**ADDENDUM NO. 06**

**Date: 08.16.2024**

**Westfield Washington School Corporation  
Westfield Middle School West  
Bid Package 02, BI:02 Building Concrete Work and BI:03 Steel and Railing Work  
17707 Centennial Road,  
Westfield, IN. 46074**

This Addendum #06, Dated 08.16.2024, forms part of the contract documents and modifies the original Bidding Documents Dated 07.26.2024. Please acknowledge receipt of this Addendum in the space provided on the Bid Form. Failure to acknowledge this Addendum may subject the Bidder to disqualification.

DRAWING NUMBER  
**L102**

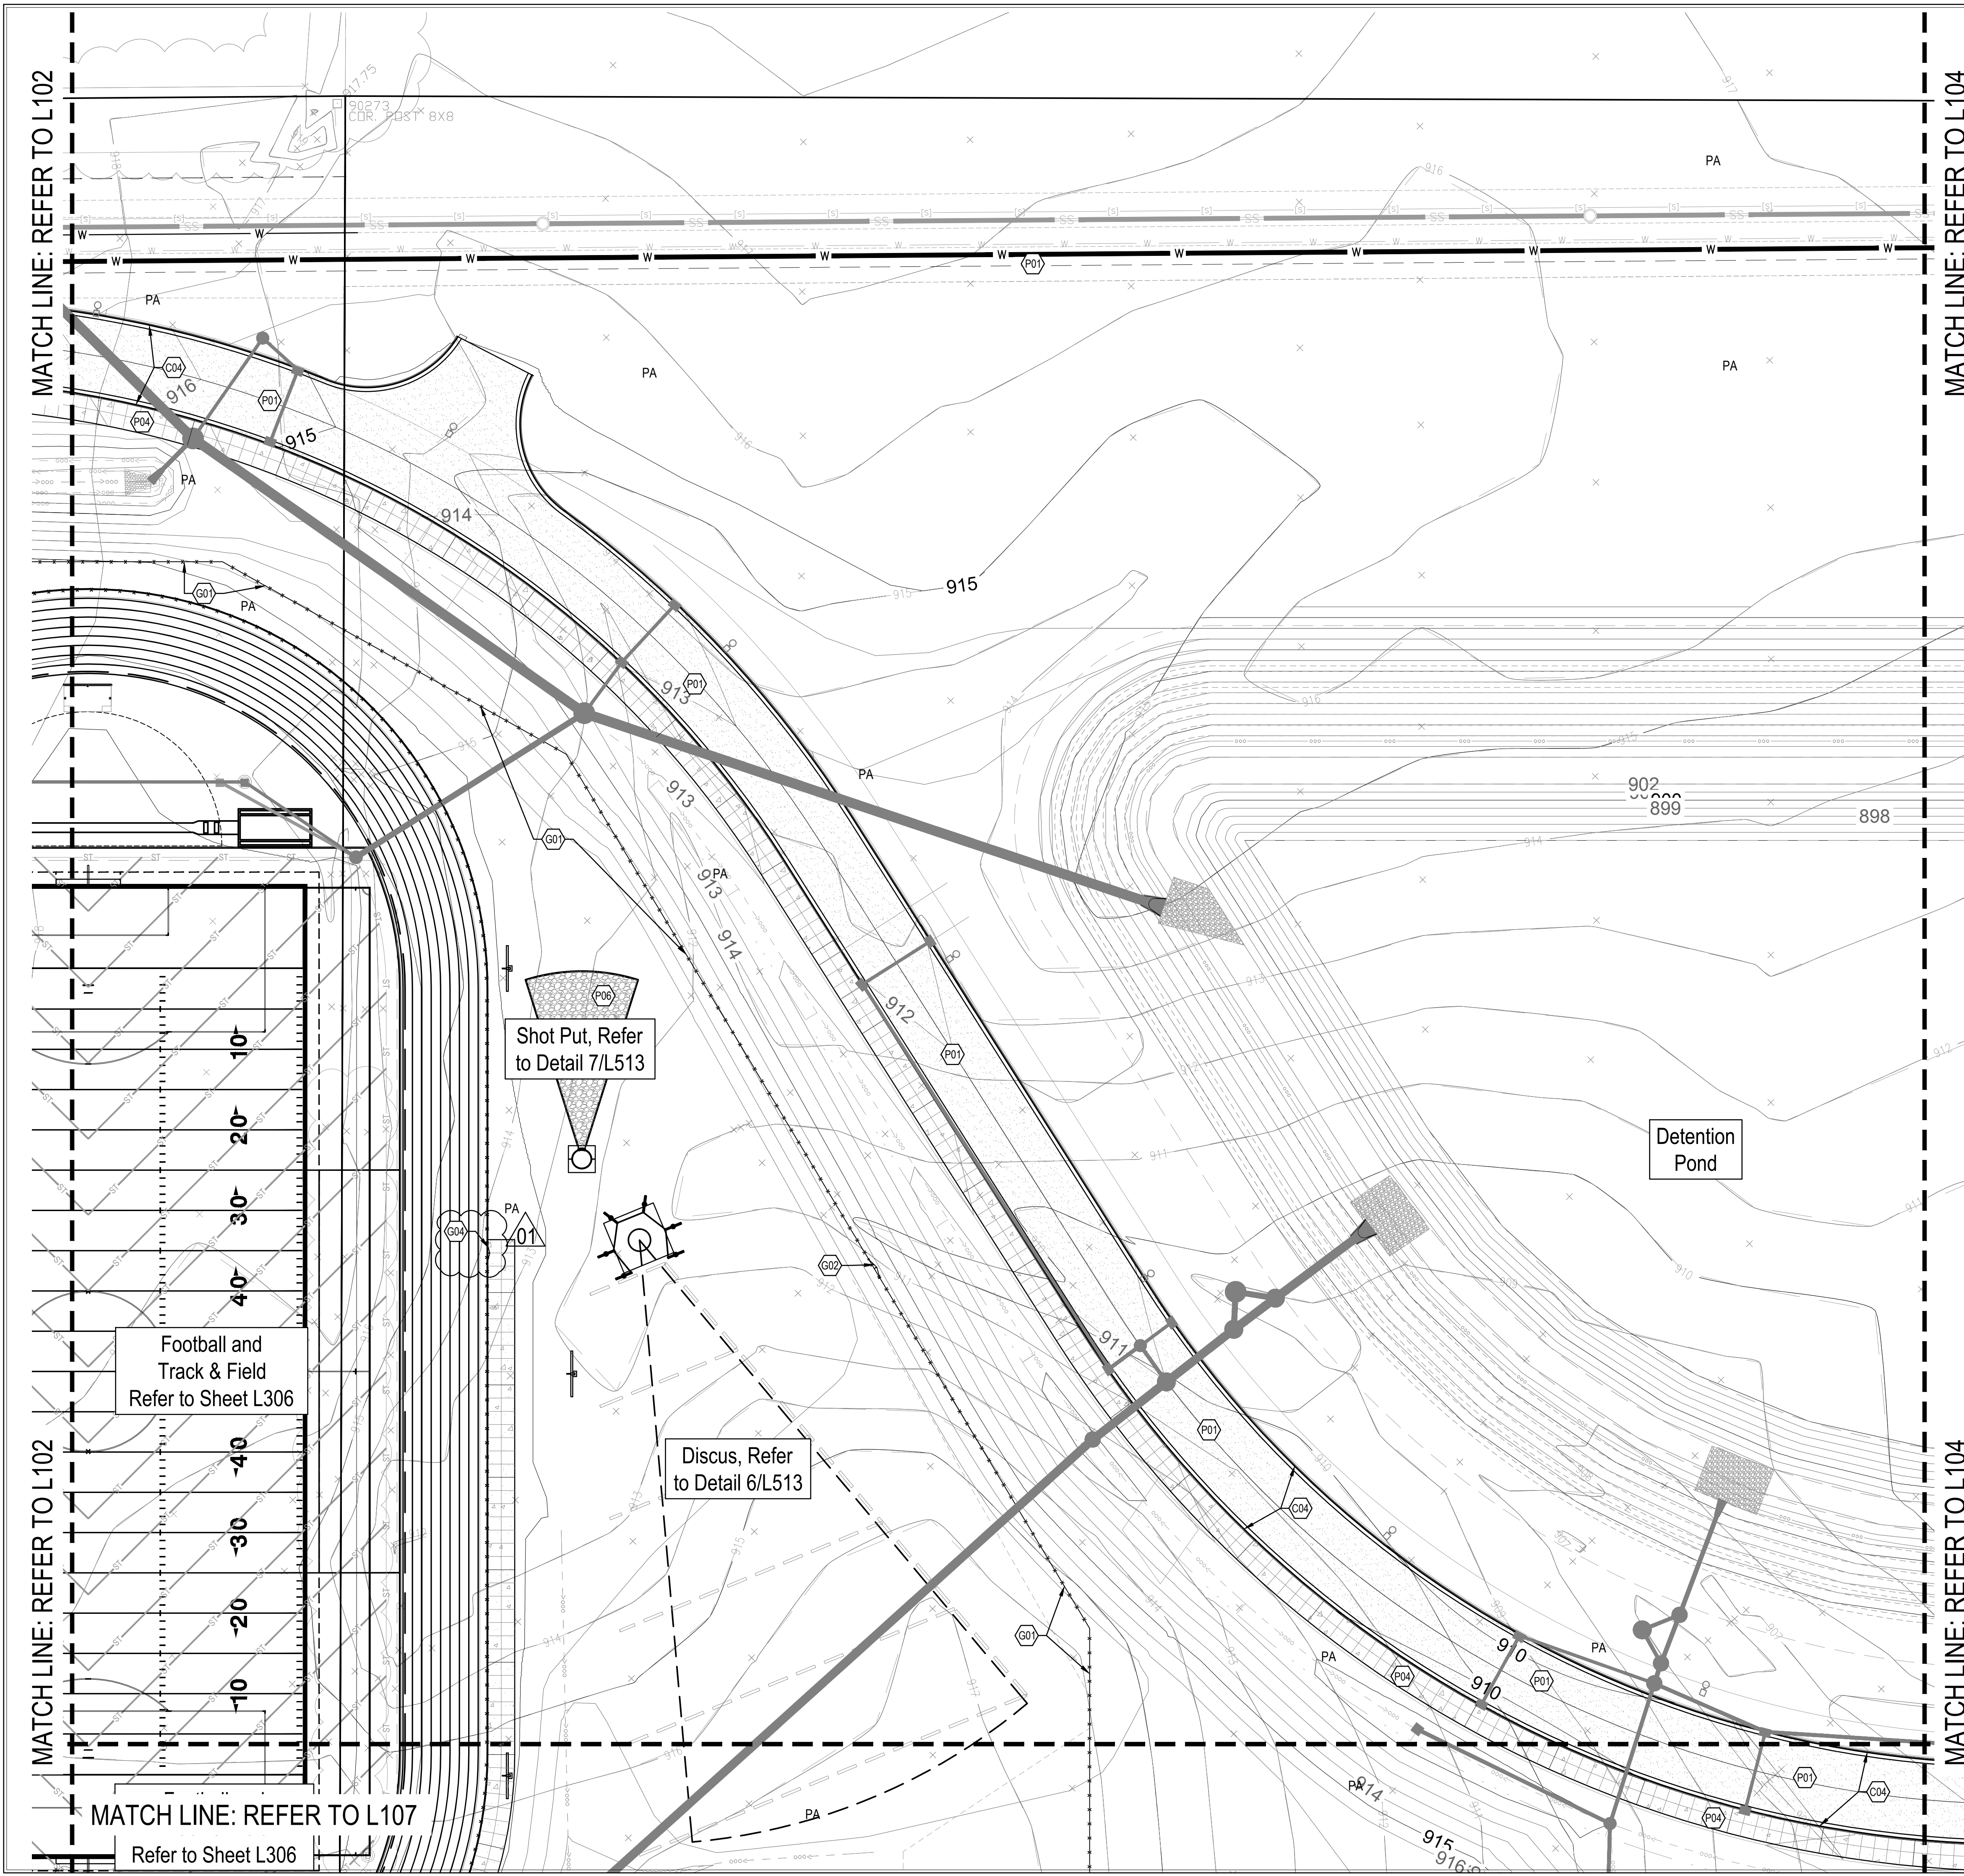
11. Bid Item #03 Steel and Railing Contractor shall amend the Pipe Bollards to the Guardrail detail at the loading dock per Legend R04 on L102 and per the detail 10/L500. So delete the ten (10) bollards along the ramp and furnish and install the galvanized guardrail at this location. Bid Item #02 Building Concrete to amend your scope for the number of bollards to install.

**DRAWING NUMBER**  
**A120**  
**PROJECT NUMBER**  
**2023061**

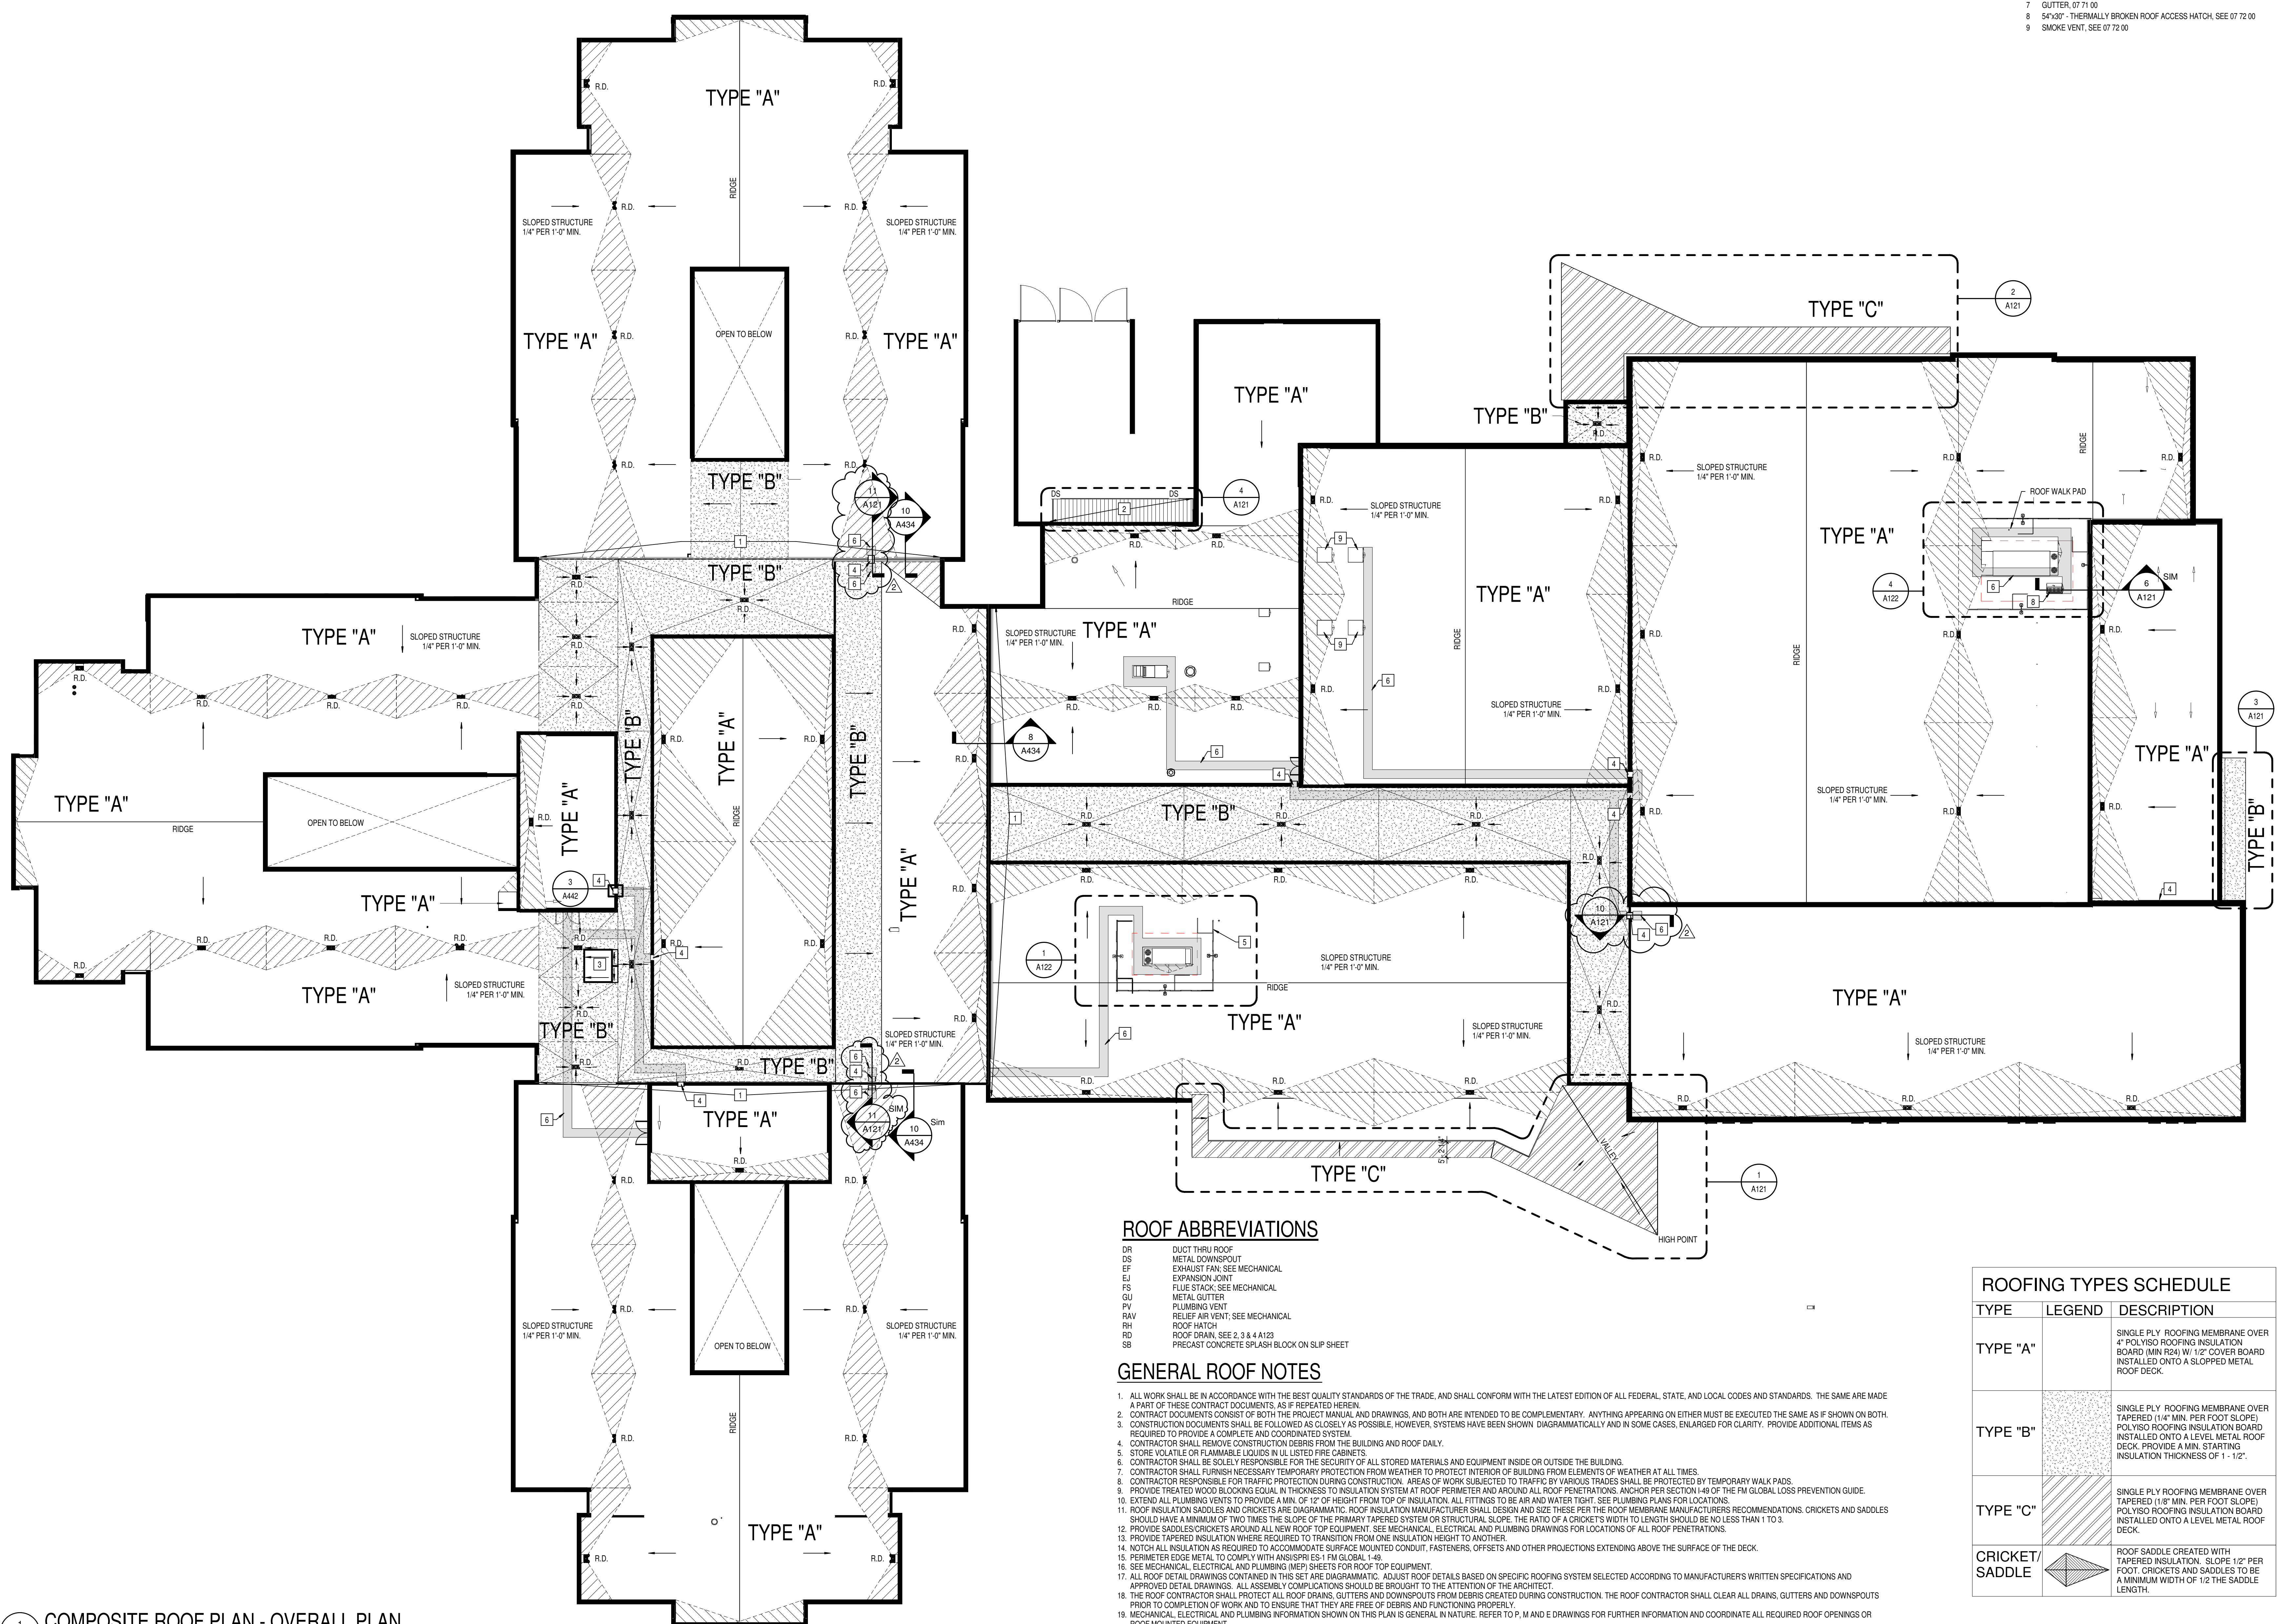
12. Bid Item #02 Building Concrete Contractor shall furnish and install the concrete foundations per the detail 2 on S201H.
13. Bid Item #03 Steel and Railing Contractor shall furnish and install the added roof ladders per the Drawing A120 and the Details 10 and 11 on A131.
